Blind Creek
Solar Farm

Tarago Road Intersection Changes to the EIS

VERSION 2

FIGURE 12 COMPARISON OF THE EIS SUBMISSION DESIGN AND THE AMENDED DESIGN.

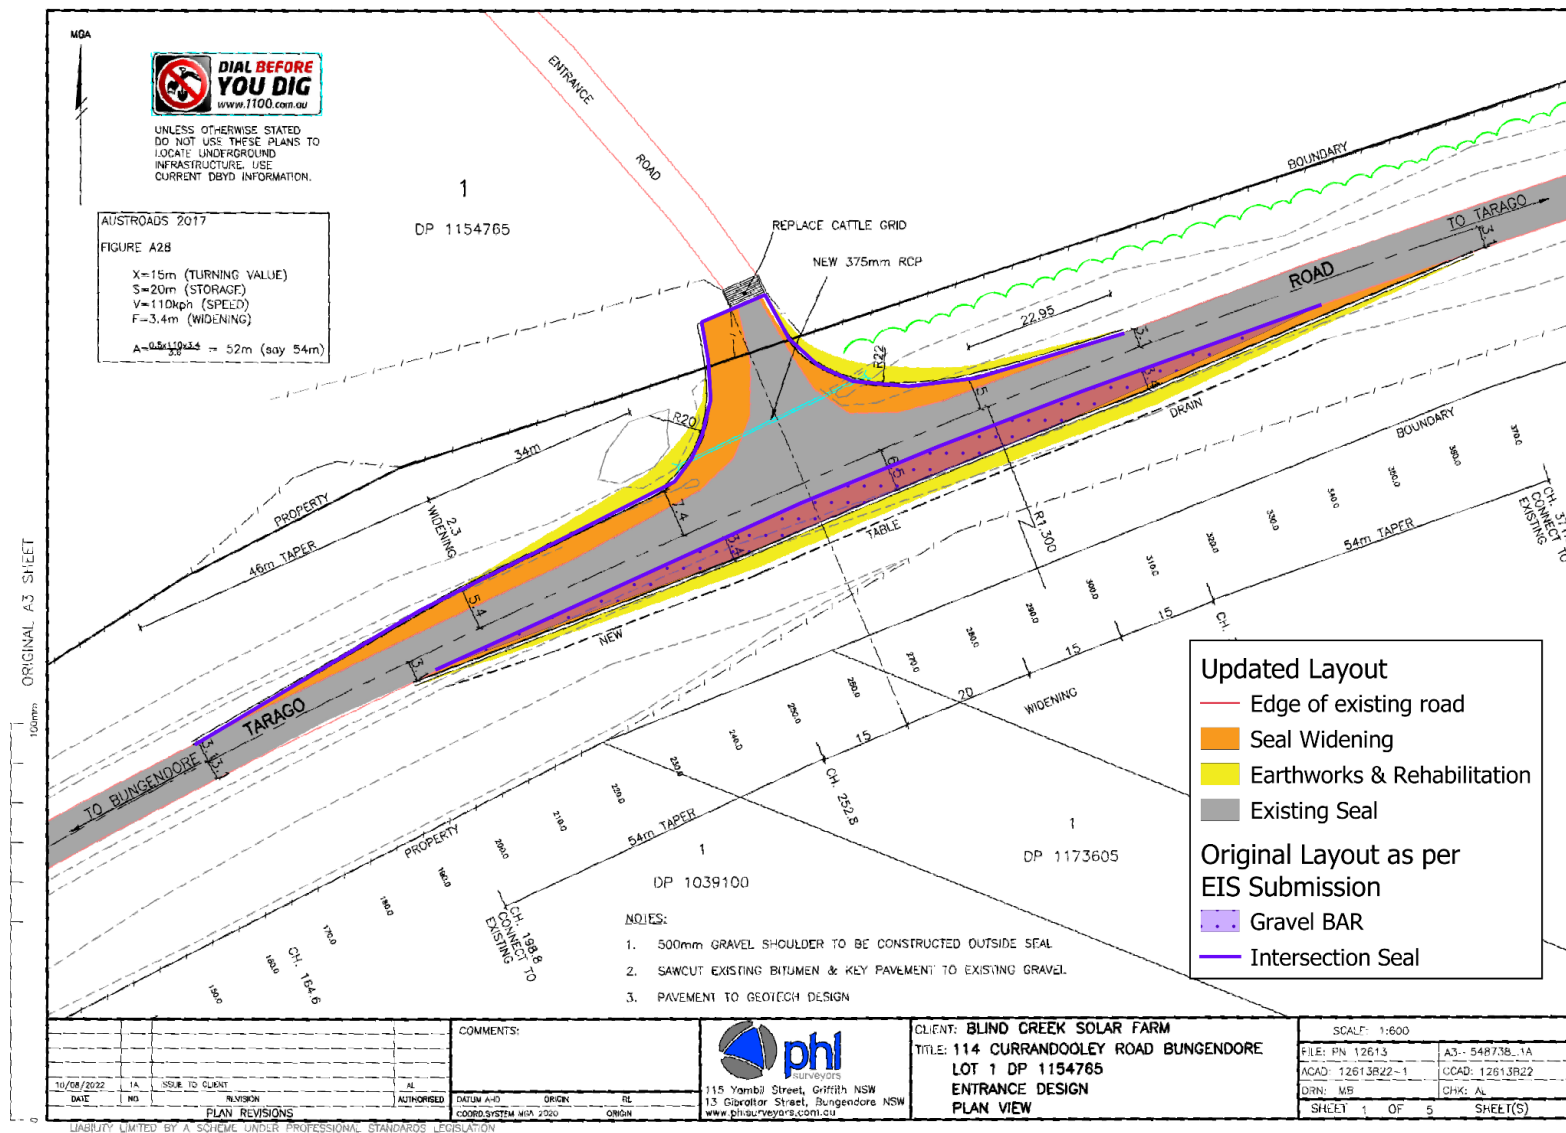
The updated intersection layout and the original layout proposed in the EIS of March 2022 are compared in Figure 12. The differences include; one further area of seal widening on the south side of Tarago Rd which was mainly shown as gravel on the original; and three clarified areas of earthworks and rehabilitation (which were not shown on the original but were planned). We note that all additional works are within the historically disturbed area identified in our topographic analysis described below.
